BULLETIN NO. 33

JEFFERSON LAB

TECHNICAL ENGINEERING & DEVELOPMENT FACILITY
(TEDF TWO)

Bulletin No.33
Project No. 20080400
March 04, 2011

TITLE: TED BUILDING WALL SECTIONS			
SCALE	DRAWING NUMBER	SHEET	REV
1/2" = 1'-0"	100024-174-A156-STE	TED-A3.2.3.16	-

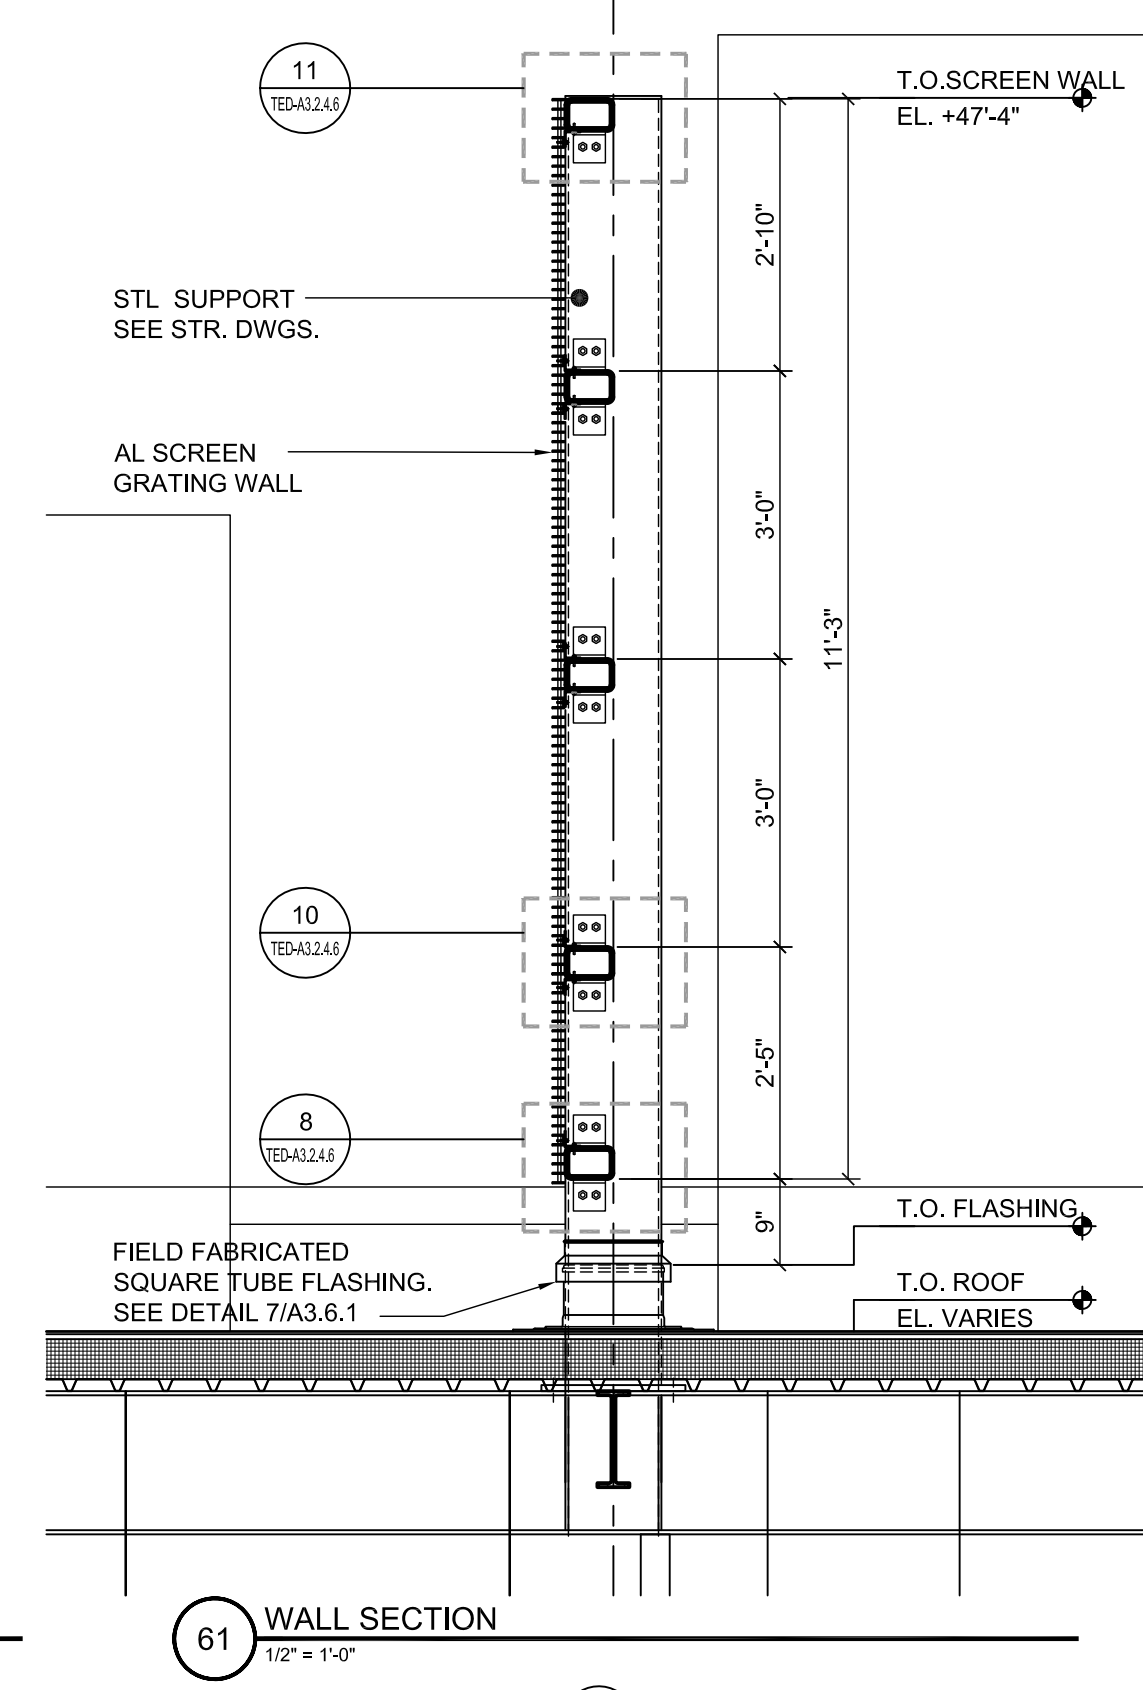
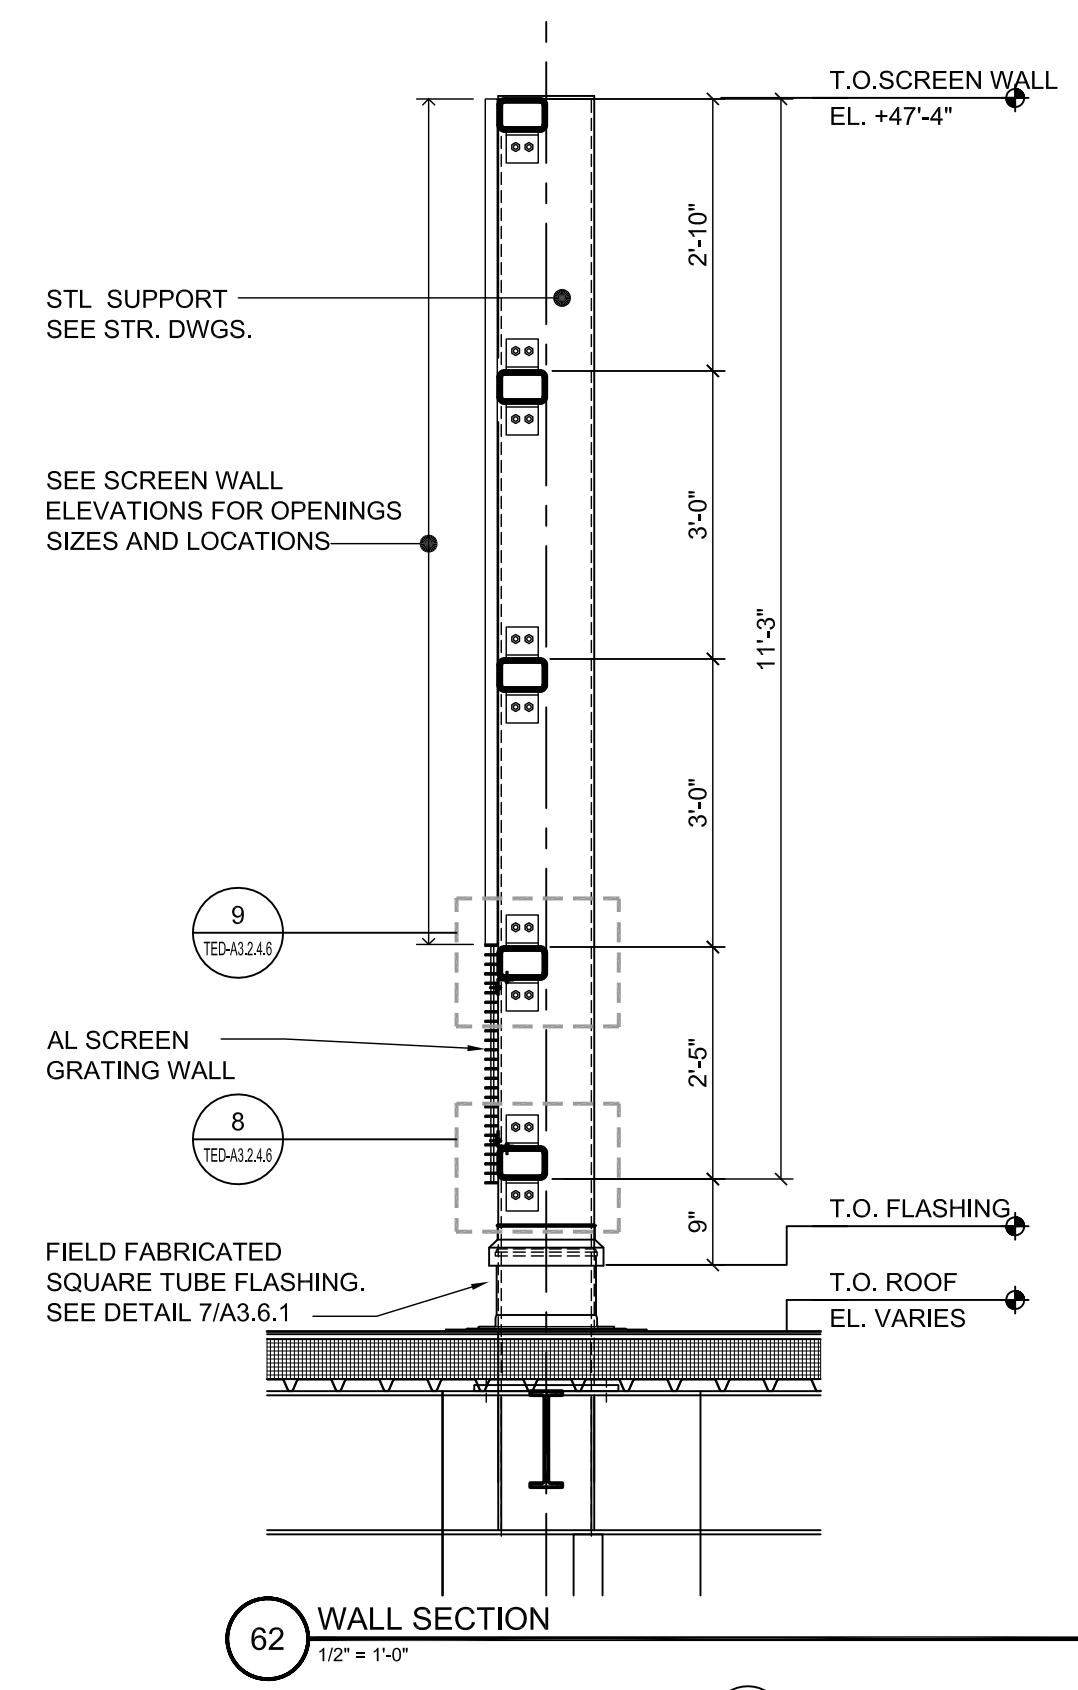
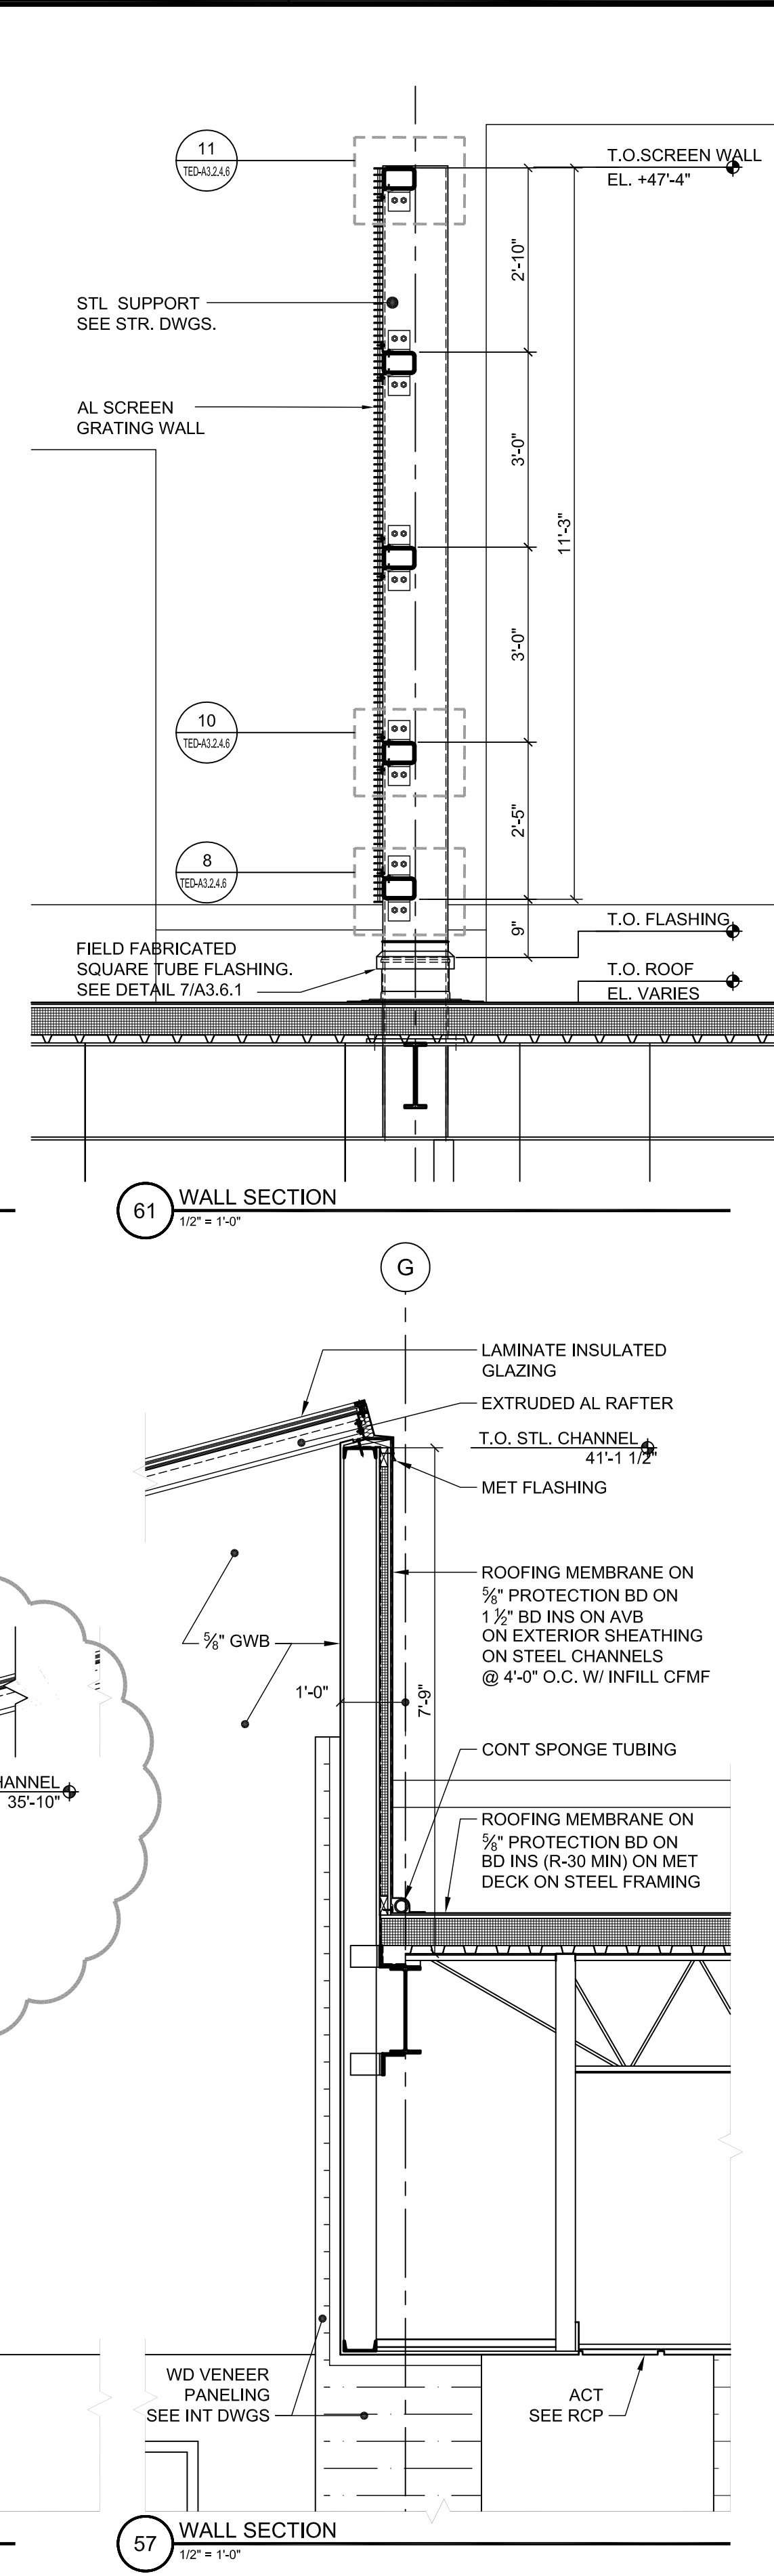
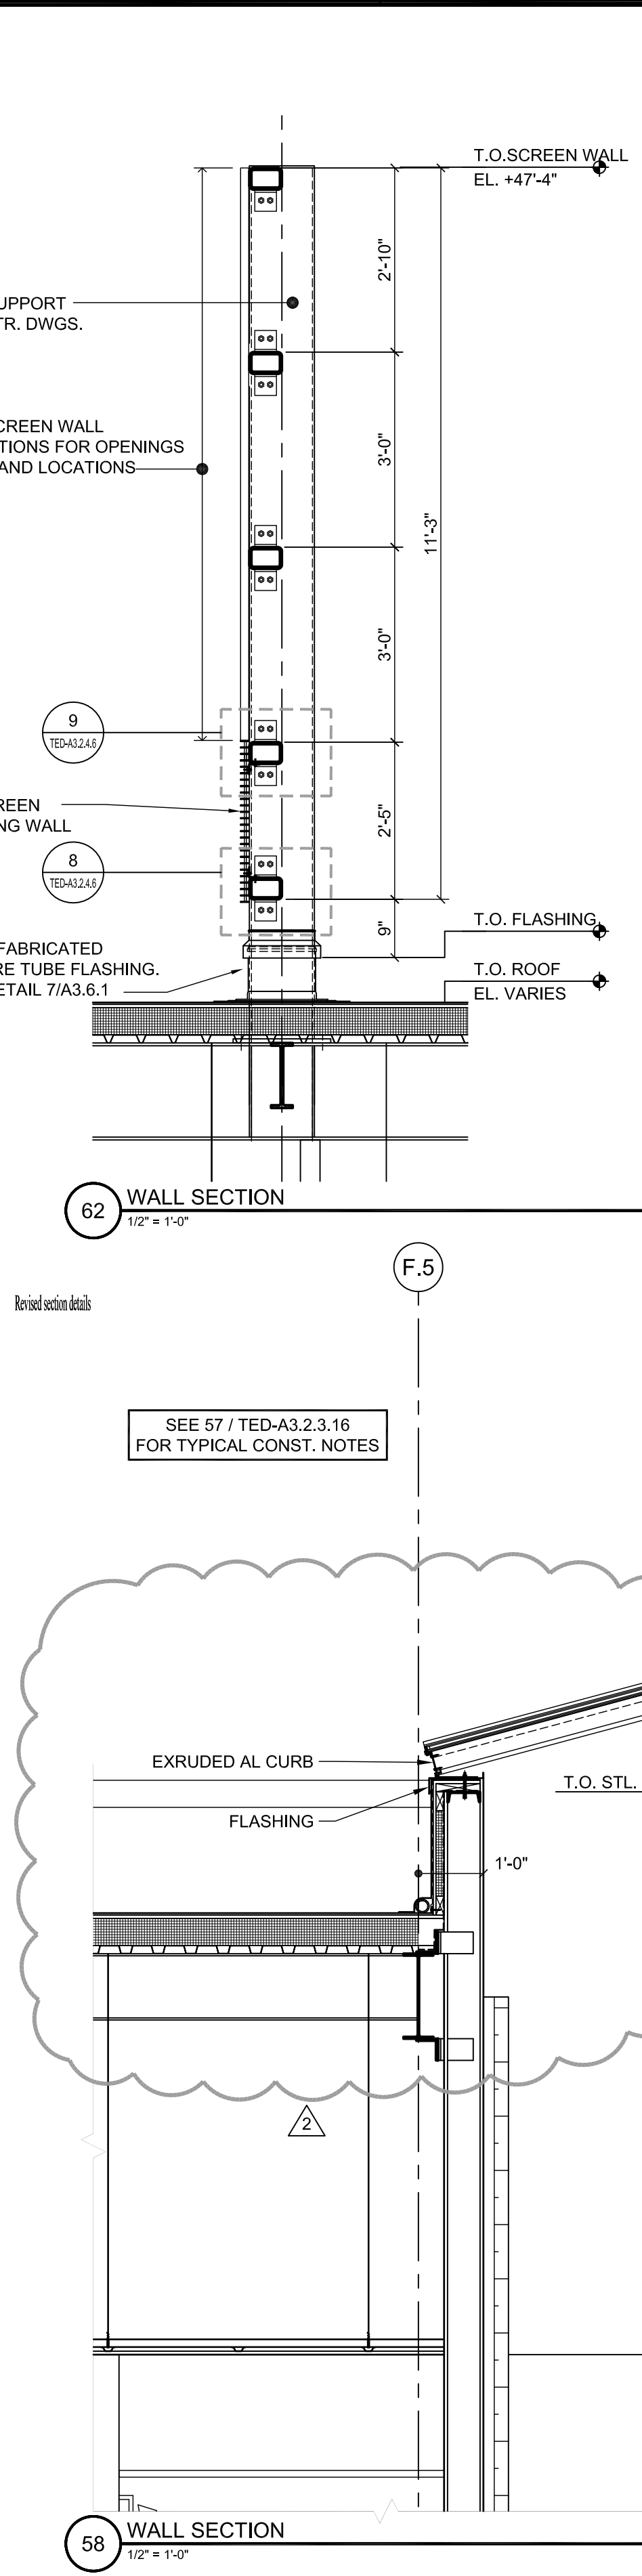
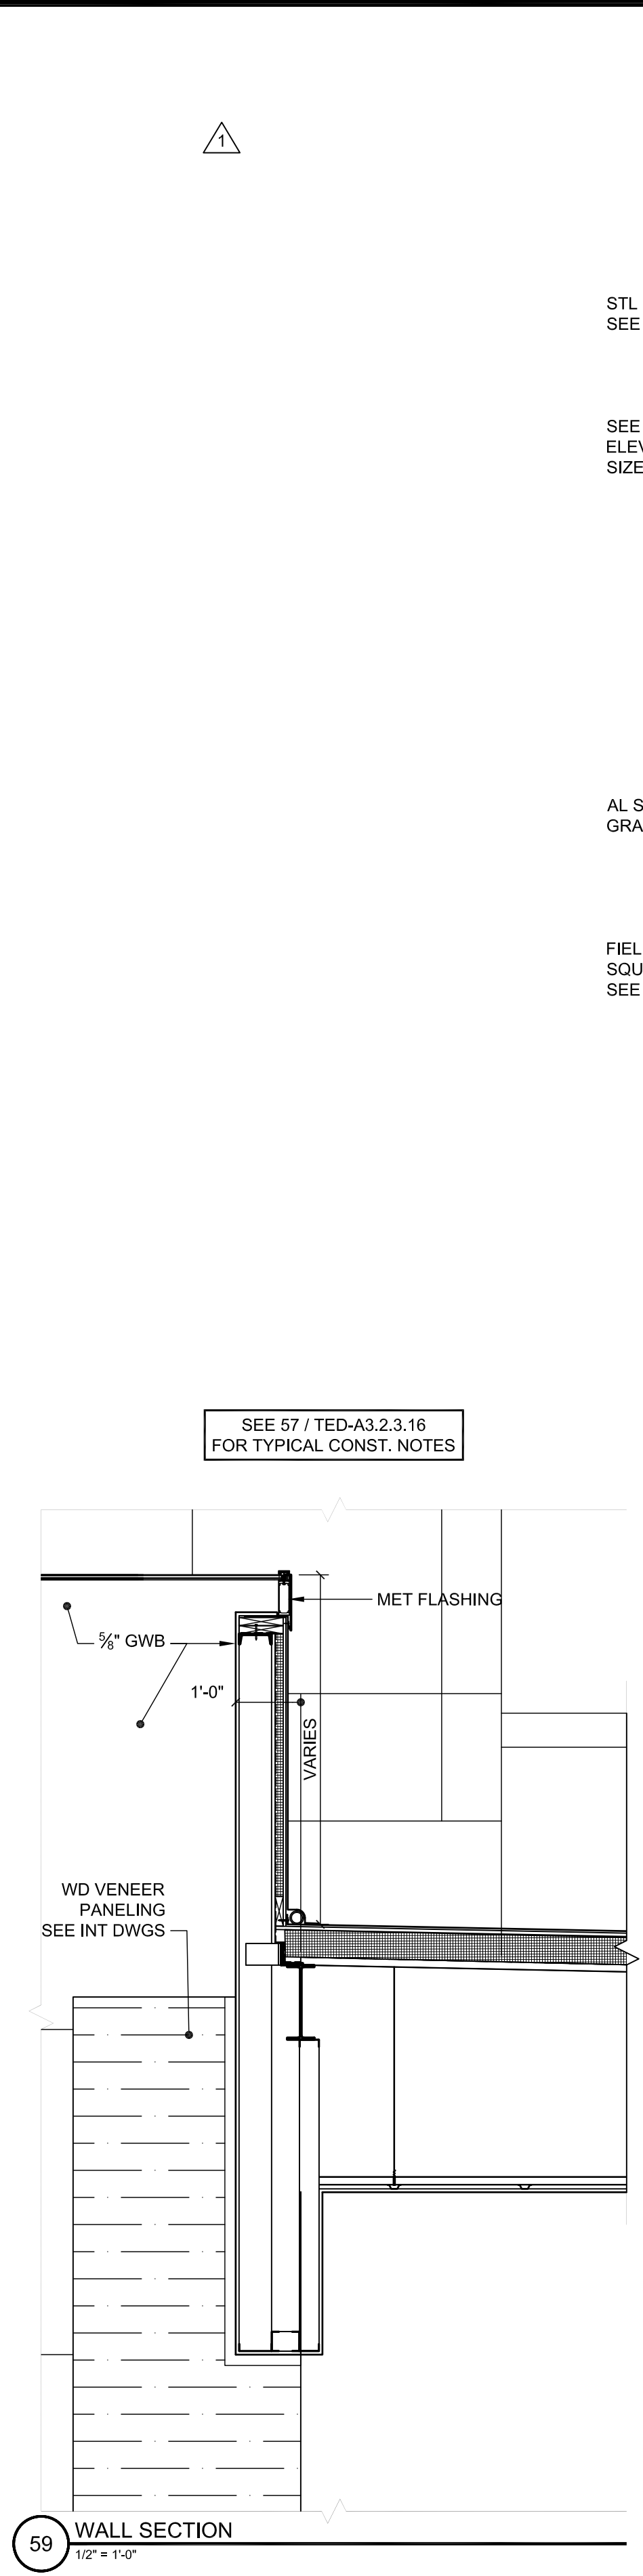
1. Revised wall sections 58 & 60/TED-A3.2.3.16
